DEVELOPMENT APPLICATION ASSESSMENT REPORT

Application Number:	DA2019/0154
----------------------------	-------------

Responsible Officer:	Catriona Shirley
Land to be developed (Address):	Lot 1 DP 373531, 1955 Pittwater Road BAYVIEW NSW 2104
Proposed Development:	Demolition works and construction of a seniors housing development
Zoning:	R2 Low Density Residential
Development Permissible:	Yes, under SEPP (Housing for Seniors or People with a Disability) 2004
Existing Use Rights:	No
Consent Authority:	Northern Beaches Council
Delegation Level:	NBLPP
Land and Environment Court Action:	Yes
Owner:	Ian Francis Westaway Jan Elizabeth Westaway J A Westaway & Son Pty Ltd
Applicant:	Ian Francis Westaway Jan Elizabeth Westaway Vaughan Milligan Development Consulting Pty Ltd

Figure 1. Shadow over the rear windows
Figure 3. Shadow still over rear windows
 and Court Yard of Unit 1 at 9.00am
 and Court Yard at 3.00pm

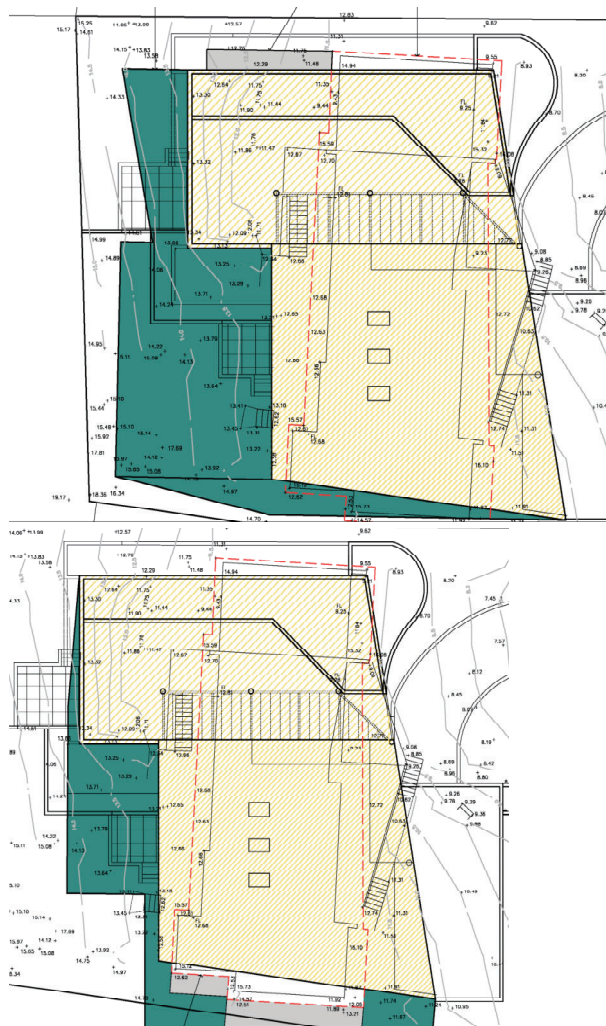
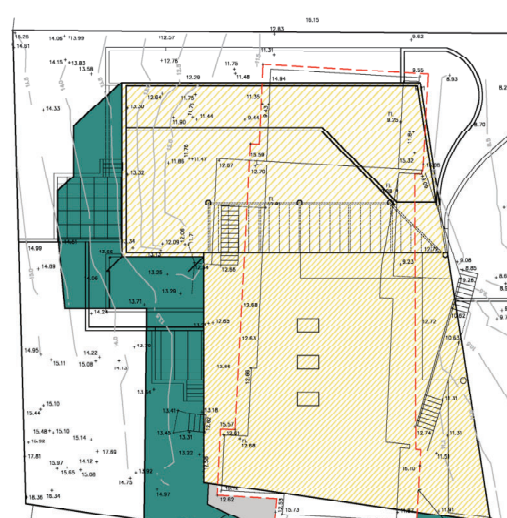
The shadow diagrams below show that the rear windows (adjoining living rooms) and courtyard of Unit 1 are in shadow between 9am and 3pm.

All areas of private open space for Units 2, 3 and 4 will receive in excess of 3 hours of direct sunlight between 9.00am and 3.00pm during midwinter.

Figure 5. Proposed Pittwater Road presentation

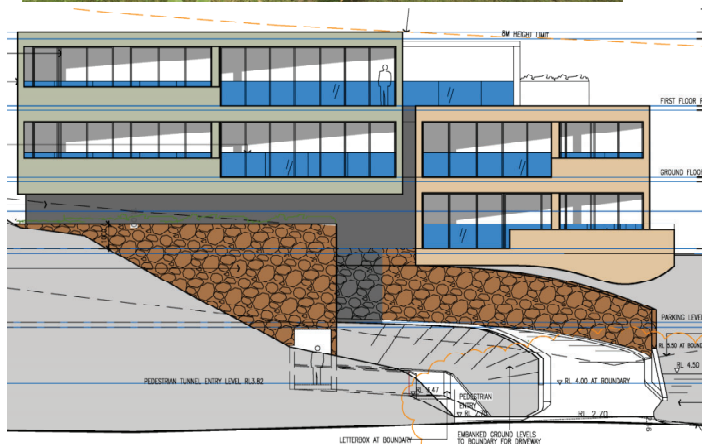
D4.1 Character as viewed from a public place

The proposed development is of a greater scale than any other development within the visual catchment of the site. The development also exceeds the built form controls prescribed by Pittwater 21 DCP and the built form development standards within the PLEP and SEPP HSPD. Overall, it cannot be said that the bulk and scale of the development is minimised in that the proposal exhibits excessive bulk, scale and mass that is not consistent with the built form of low-density "detached" style housing in the surrounding area as shown below.
